Attachment 2: Responses to submission themes on Paneke Pōneke - Draft Bike Network Plan

The following table shows 378 themed comments were developed from the submissions. These were grouped into six areas. Consideration of the feedback has resulted in officers' recommending 23 changes to the draft plan. 38 actions are being added to the minor works programme.

Figure 2 Map of recommended changes in Onslow, Wadestown and Wilton

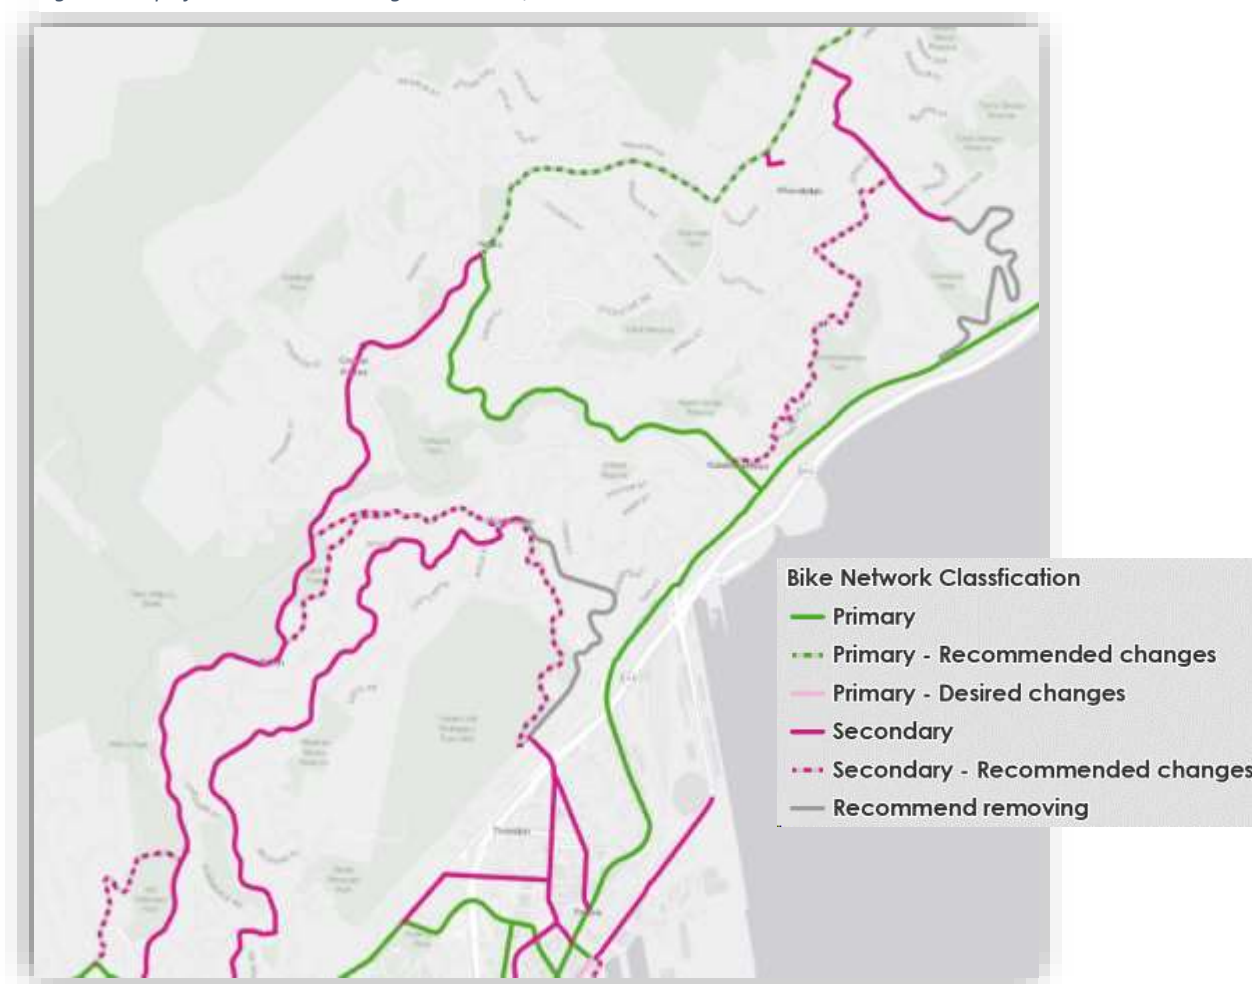
Location	Comment theme	Officer response
	Currently narrow & unsafe	People on bikes require separation from higher traffic volumes and speeds. This is a consideration for the next stage which is developing concept designs.
	Currently manhole covers are obtrusive (and on way to Khandallah)	Review safety of service covers as part of the minor works programme.
	Expand network north of Ngaio	All other streets are local, tertiary connections and not recommended for inclusion in the strategic bike network.
Onslow Road		
	This route is currently too dangerous/narrow for cyclists	Acknowledge that the width of Onslow Road below Cashmere School is very difficult to improve and is unlikely to be achievable in the foreseeable future. Recommend removing the secondary designation on Onslow Road below Cashmere School.
	Consider other routes instead (e.g. bridle track)	Recommend adding bridle track to Cashmere Ave via Nicholson Road, Jubilee Road, Iazard Road and Ranui Crescent to the secondary network.

Bridle track		
	Connect the network via the bridle track	Recommend adding bridle track to Cashmere Ave via Nicholson Road, Jubilee Road, Iazard Road and Ranui Crescent to the secondary network.
	Currently has high usage	As above.
	Would be a great connection to the city for e-bike users	As above.
Ngaio Gorge Road		
	Make sure cycleway is separated/protected	People on bikes require separation from higher traffic volumes and speeds. This is a consideration for the next stage which is developing concept designs.
	Consider bus/bike only for early commuting hours	People on bikes require separation from higher traffic volumes and speeds. This is a consideration for the next stage which is developing concept designs.

Figure 3 Map of recommended changes in Karori, Northland and Kelburn

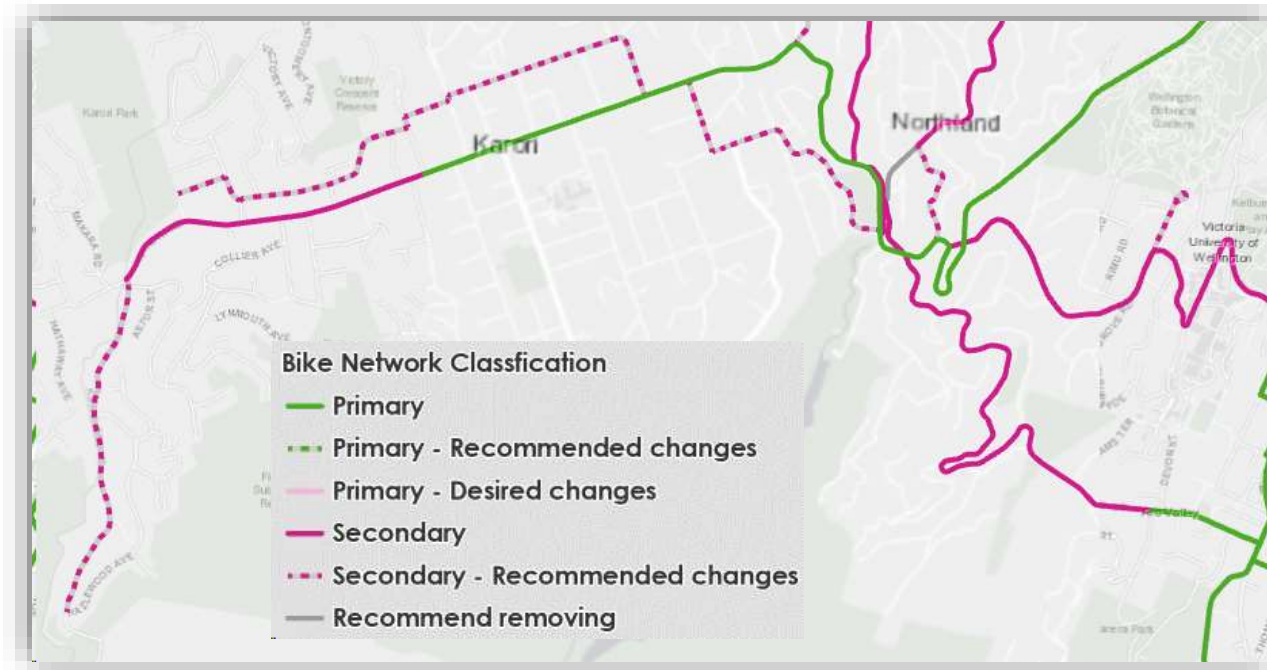
Location	Comment theme	Officer response
	Find an alternative, if possible (e.g. Northland Rd)	Recommend Northland Tunnel Road be removed from the strategic network and Northland Road from Glenmore Street to Northland shops be added as a secondary connection.
Raroa Road/Cres & Aro Street		
	Make sure it is easy to access Brooklyn cycleway from Aro St	This is a consideration for the next stage which is developing concept designs. Ensure this connection is in the scope of the current Brooklyn Hill transformation project.
	Currently very dangerous due to close proximity to vehicles & buses (introduce traffic calming measures)	People on bikes require separation from higher traffic volumes and speeds. This is a consideration for the next stage which is developing concept designs.
	Consider adding Polhill track as a connection - this is often used by commuters	Tracks in this area are not considered appropriate for upgrading to high-quality bike friendly facilities and therefore should not be included in the strategic bike network. The area is now named Waimapihi Reserve, it is a proposed Significant Natural Area in the draft District Plan and is part of the Town Belt.

Location	Comment theme	Officer response
	Friend St/Homewood St may be a better alternative	Recommend adding Karori Park to Friend Street and Hatton Street as secondary network.
	Connecting to Vera Street	Local street connections are not recommended to be part of the strategic bike network.
	Consider adding routes heading south within Karori (with vehicle speed reduction)	Local street connections are not recommended to be part of the strategic bike network.
	Make vehicle speed limit 30 km/h for whole length of Karori Rd to improve safety	While this is a consideration for the next stage which is developing concept designs, reducing speeds for most of the route is unlikely to be a good solution on its own. Speed limits will be reviewed as part of the Council's speed management programme which will start in 2023.
	Consider adding traffic calming measures	This is a consideration for the later detailed design stage.

Figure 4 Map of recommended change in the central area

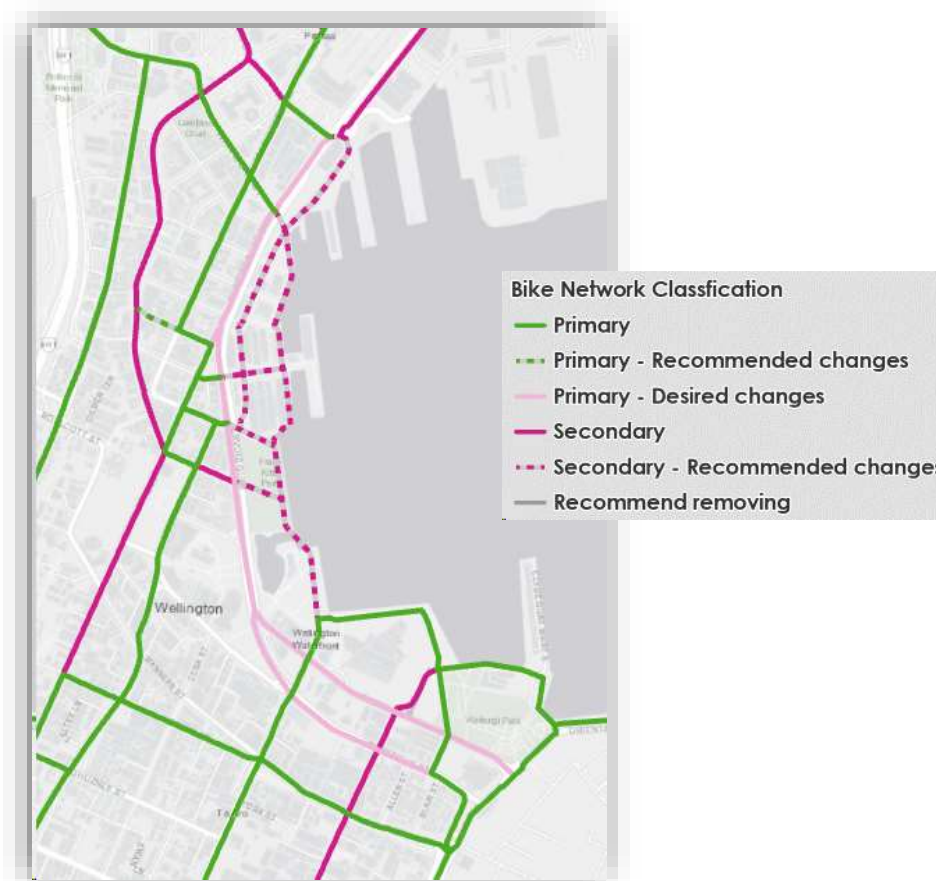
Route should be pedestrian priority, and cyclist diverted to alternatives (e.g. Lady Elizabeth Lane, Jervois Quay)	Recommend adding Lady Elizabeth Lane as part of the secondary network and investigating cycling improvements as part of the minor works programme. The area, being part of the waterfront, is pedestrian priority shared space.
	Include more bicycle traffic lights	We will add specific connections to minor works programme when they are identified as a priority.
	Increase access to Willis St & Lower Cuba/Wakefield St from waterfront by adding a kerb cut from Bond St onto Willis St	This is part of the scope for consideration in LGWM's Golden Mile project. However, encouraging bike access to Willis Street from Bond Street is inappropriate while the adjacent section of Willis Street is a Bus Only lane.

Figure 5 Map of recommended changes in Brooklyn, Mornington, Berhampore and Newtown

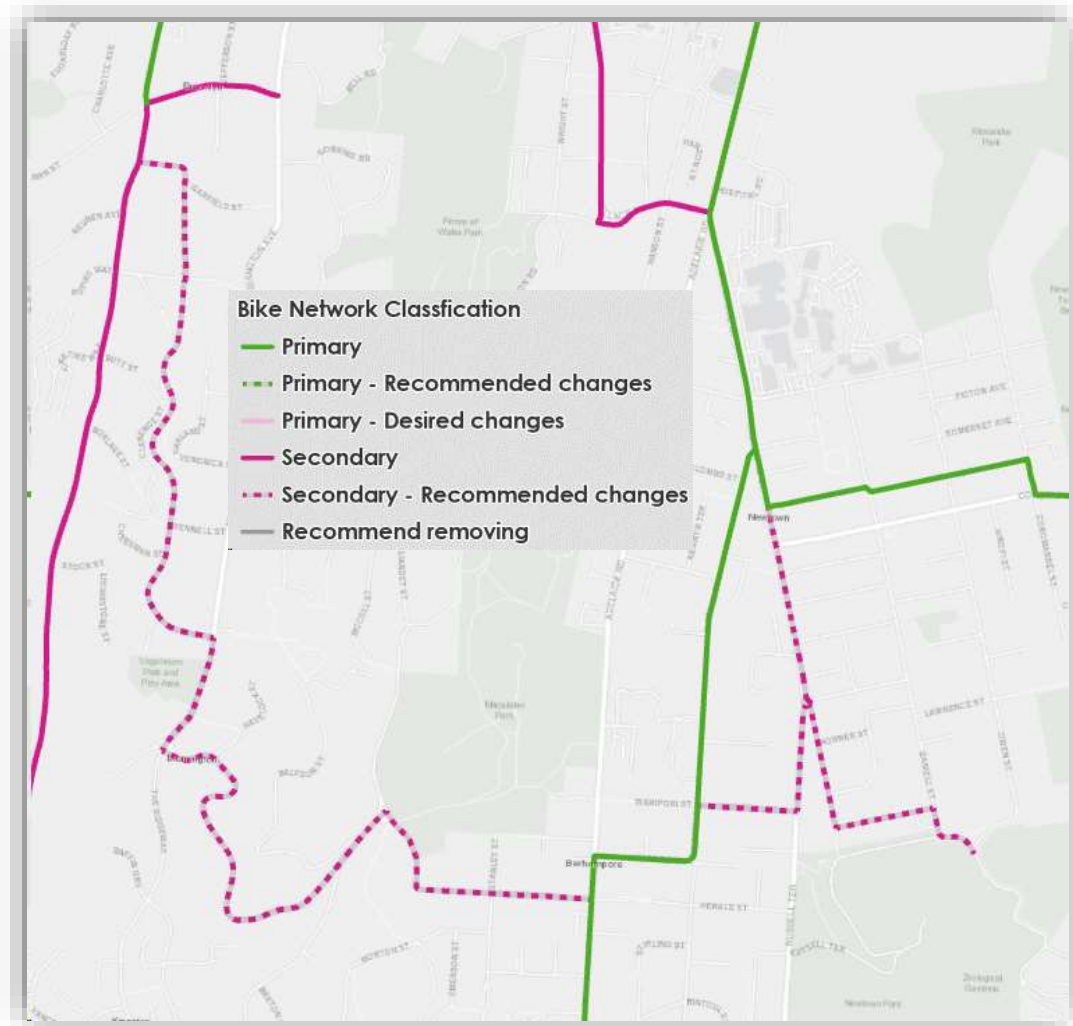
Location	Comment theme	Officer response
	Better connect to Brooklyn & Ridgeway Schools	Local connections to schools will be developed through either the minor works programme, or the school accessibility programme. Recommend adding McKinley Crescent to Mornington Road to Ridgeway School, and Farnham Street and Britomart Street as a secondary connection.
	This route is currently unsafe with poor weather	Poor weather is not something that can be addressed through reengineering street space. People who ride bikes should consider alternatives for travelling during unfavourable weather conditions.
	Preference for Mornington Rd due to traffic flow/safety	Recommend adding McKinley Crescent to Mornington Road to Ridgeway School, and Farnham Street and Britomart Street as a secondary connection.
	Better connect Brooklyn with the East	As above.
	Base of Brooklyn hill is currently very unsafe	Improvements are currently being developed as part of the Brooklyn Hill transformation project.

Newtown/Riddiford Street		
	Extend route through the centre of Newtown	Recommend adding the following secondary corridors to better connect the Newtown centre, Newtown Park, the zoo, and South Wellington Intermediate School: <ul style="list-style-type: none"> • Riddiford Street from Wilson Street to Russell Terrace • Russell Terrace to Te Wharepouri Street and Te Wharepouri Street • Mansfield, Roy and the south end of Daniell streets.
	Consider using the whole of Riddiford St	As above.
	Lower speeds in Newtown to 30 km/h or separated cycleway due to narrow roads	This is a consideration for the next stage which is developing concept designs. Speed limits will be reviewed as part of the Council's speed management programme which will start in 2023.

Use Britomart St	Recommend including as part of the Mornington connection.
	Use Te Wharepōuri Street	Recommend adding the following secondary corridors to better connect the Newtown centre, Newtown Park, the zoo and South Wellington Intermediate School: <ul style="list-style-type: none"> • Riddiford Street from Wilson Street to Russell Terrace • Russell Terrace to Te Wharepouri Street and Te Wharepouri Street • Mansfield, Roy and the south end of Daniell streets.
	More cycleways in the town belt	Any future proposals would need to be consistent with the settings in the Town Belt Management Plan. In general, the town belt is not suitable for developing high-quality, bike friendly commuting routes. We will investigate options that can complement the strategic network as these are identified.

Location	Comment theme	Officer response
	Russell Terrace has large amount of unused parking	<p>Recommend adding the following secondary corridors to better connect the Newtown centre, Newtown Park, the zoo and South Wellington Intermediate School:</p> <ul style="list-style-type: none"> • Riddiford Street from Wilson Street to Russell Terrace • Russell Terrace to Te Wharepouri Street and Te Wharepouri Street • Mansfield, Roy and the south end of Daniell streets.
	Include Mansfield St	<p>Recommend adding the following secondary corridors to better connect the Newtown centre, Newtown Park, the zoo and South Wellington Intermediate School:</p> <ul style="list-style-type: none"> • Riddiford Street from Wilson Street to Russell Terrace • Russell Terrace to Te Wharepouri Street and Te Wharepouri Street • Mansfield, Roy and the south end of Daniell streets.
	Include Bidwill St	Local street connections are not recommended to be part of the strategic bike network.
